To	Mike Thiagaram/Martin Derby	Location	NJ,Amherst-NY	Date	May 3, 2003
From	Mambu Kawa	Location	NJ	Job No.	61440-2.01
Subject	Richardson Hill Landfill	Reference	Slurry Calculations Review

RE: **Richardson Hill Road Landfill Site  
Remedial Action Work Plan (RAWP) - Earthwork- Stage 2 Task Comments and  
Comments to Site Operation Plan for Groundwater Extraction Trench Construction**

**COMMENTS TO STAGE 2 TASKS OF REMEDIAL ACTION WORK PLAN  
FOR EARTHWORK CONSTRUCTION AT THE  
RICHARDSON HILL ROAD LANDFILL SITE  
(DATED MARCH 2003)**

Trench stability.xls

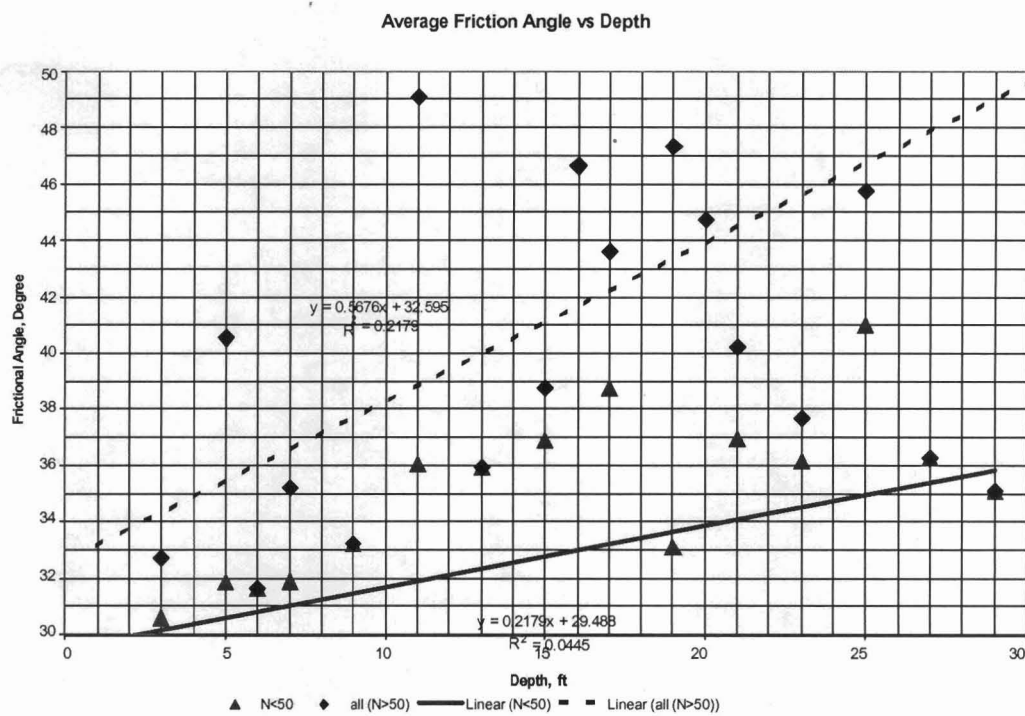
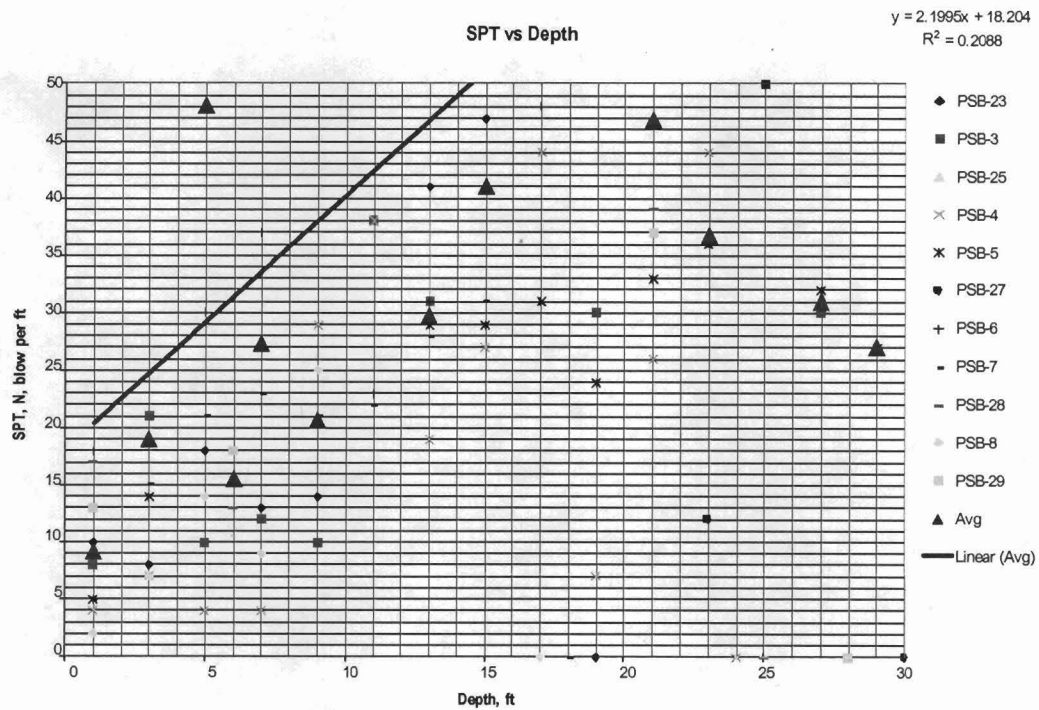
A review of the spreadsheet calculations for PSB-23 for example shows the lateral force due to the surcharge to be negative. This results in a reduced Total Driving Force, giving a factor of safety of 1.21. If however the cohesive strength is omitted, the Total Driving Force increases, and the factor of safety drops to 0.88. (See attached calculations).

3. The lateral force computed due to the surcharge is negative. In effect the calculations are saying that the surcharge provides a resisting force not a driving force, in practice an unlikely possibility.

1. Using the same angle of friction for the entire soil renders the calculations amenable to the use of a spreadsheet. However the values used may be high based on the blow counts for the top 7', of soil. It may be more advisable to break the 30' of soil into layers, and assign representative friction strengths to each layer. If the same frictional strength is to be used for the entire 30', then the angle of frictions must be more conservative than the values being used at present.
2. It is my opinion that the cohesive strength should not be used, as stated before. If you decide to use it however, it cannot be applied selectively to only the surcharge lateral pressure term. The cohesive strength is a property of the soil, not the surcharge, and should be applied to all the lateral pressure terms of the soil i.e.

$$K_a \times (\text{vertical soil pressure}) - 2 \times c \times \sqrt{K_a} \text{ instead of } K_a \times (\text{vertical soil pressure})$$

$$(K_a \times (\gamma_1 \times (E1 - E2)) - 2 \times c \times \sqrt{K_a}) \times (E1 - E2) / 2 \text{ instead of } (K_a \times (\gamma_1)) \times (E1 - E2) \times (E1 - E2) / 2$$

The current use of the cohesion in the equations in the spreadsheet is therefore incorrect.
